AERONAUTICAL MOBILE COMMUNICATIONS PANEL (AMCP)

EIGHTH MEETING

**PROPOSAL FOR ICAO AMSS SARPS AND GNSS SARPS
HARMONIZATION**

(Presented by V. Bondarenko)

**Figure 2. Comparison of Annex 10 requirements for AES and GLONASS**

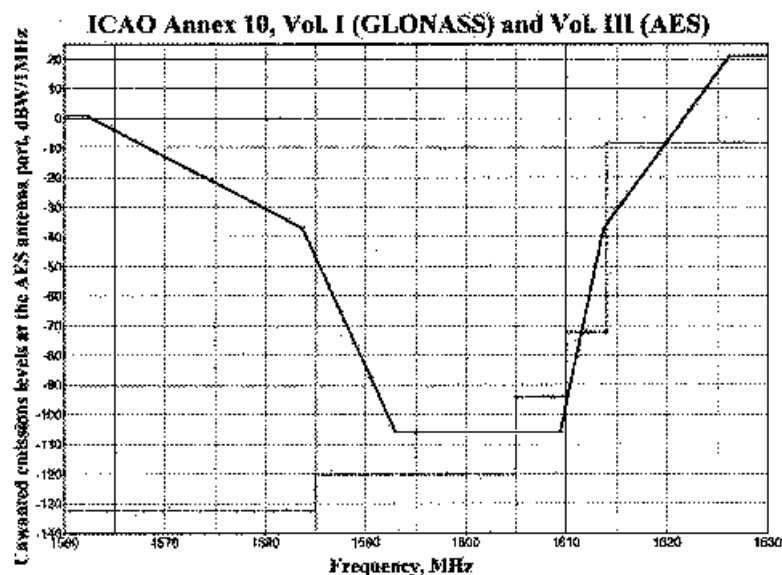
2.10 A solid line in Figure 2 shows allowable levels of interference to GLONASS receivers used onboard Satcom equipped aircraft with account of the safety margin. A dotted line shows the unwanted emissions level at the AES antenna port.

2.11 Figure 2 shows that for frequencies above 1 605 MHz the AES unwanted emissions levels exceed interference thresholds of GLONASS receivers. Such an exceeding is equal to 11.8 dB in the 1 605 - 1 610 MHz band.

2.12 Thus, under application of the mentioned AMSS SARPs there is a possibility of interference to GLONASS receivers from unwanted emissions of Satcom equipment if both GLONASS and Satcom equipment are operated simultaneously onboard the same aircraft.

2.13 Taking into account that allowable interference levels for GLONASS receivers are dictated by existing ICAO requirements for accuracy and efficiency of navigation solutions, it appears expedient to revise requirements for AES unwanted emissions.

- a) consider the discrepancy between AES allowable unwanted emissions levels and GLONASS receiver interference thresholds highlighted in this document; and
- b) recognize the need to harmonize the AMSS SARPs with the GNSS SARPs and initiate a harmonization process.
